Fermi 3

Fermi 3 Quality Assurance Program Description

Revision 1, Including
NDLCR-09-046-P02

Revision 1, including attached markups dated 9-30-2009 (NDLCR-09-046-P02).

**Figure II.1-1
Fermi 3 Pre-COL Organizational
Structure**

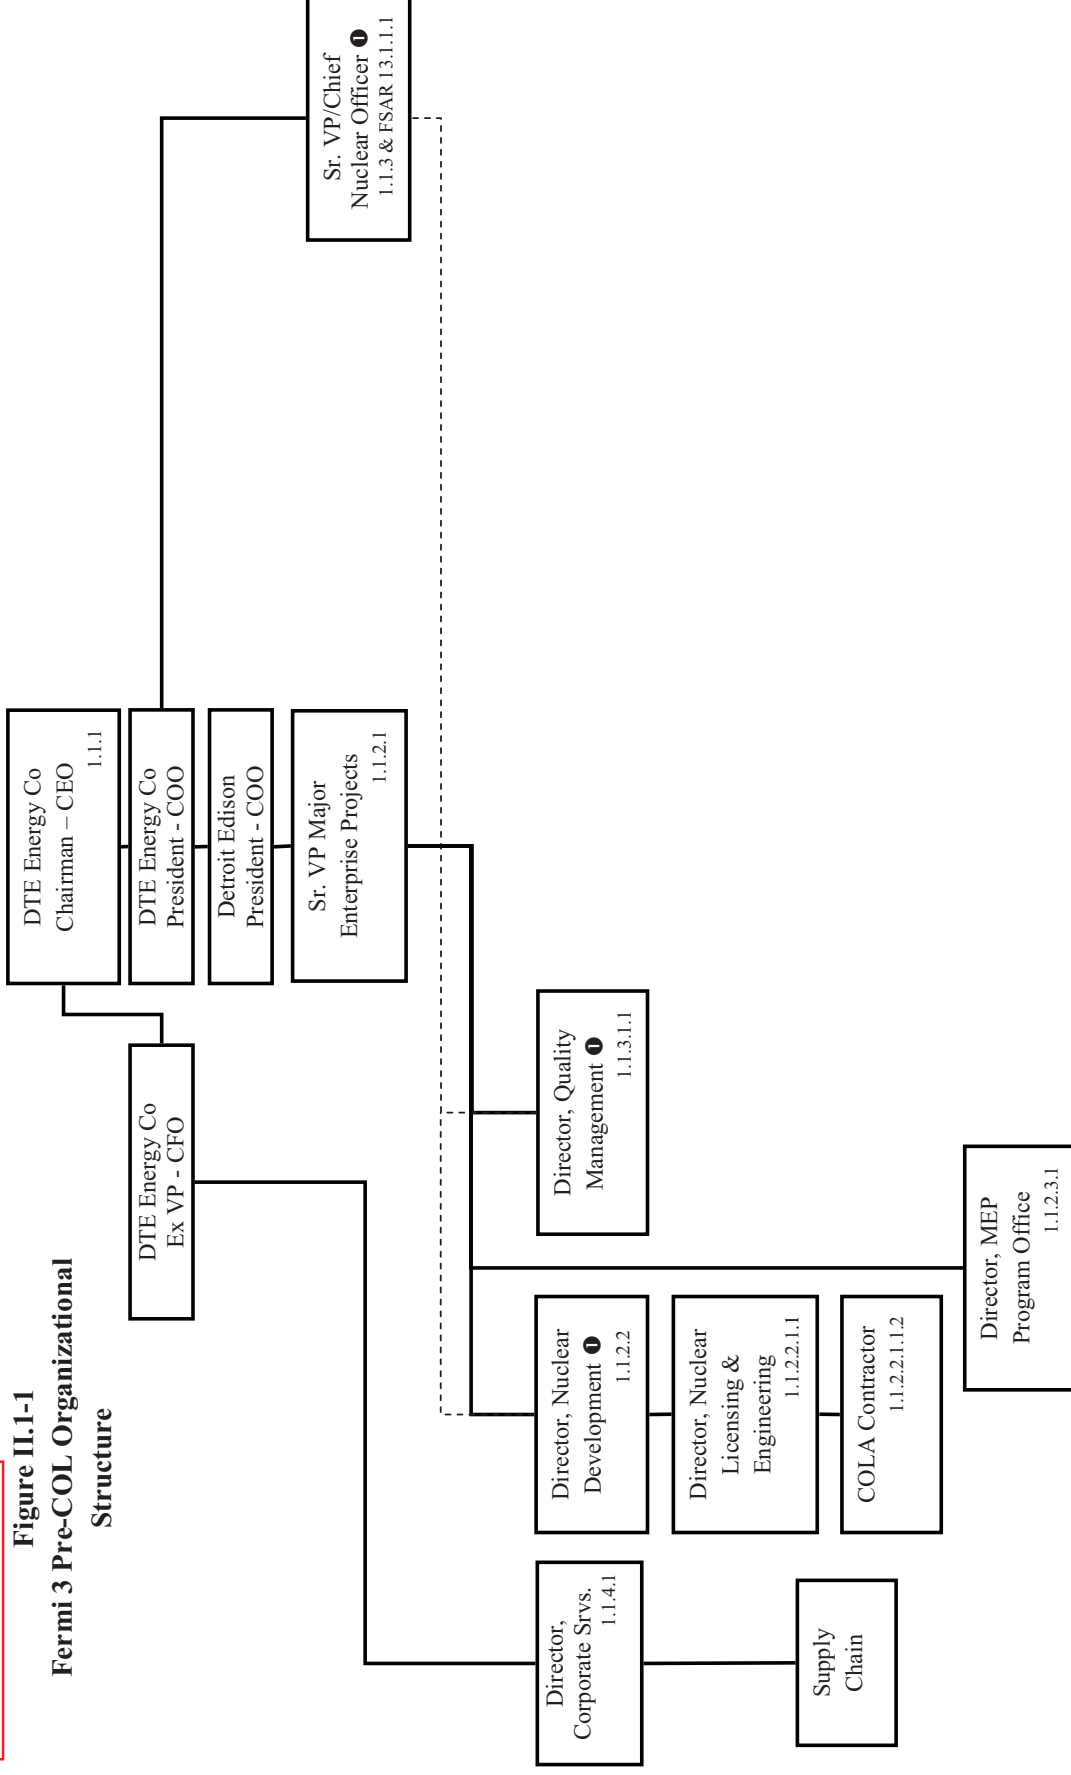
Delete Section 1 Organization, and replace with Insert 1

This section describes the organizational structure for the COL application activities of Fermi 3 and the Fermi 3 Pre-COL organizational structure is shown in Figure II.1-1.
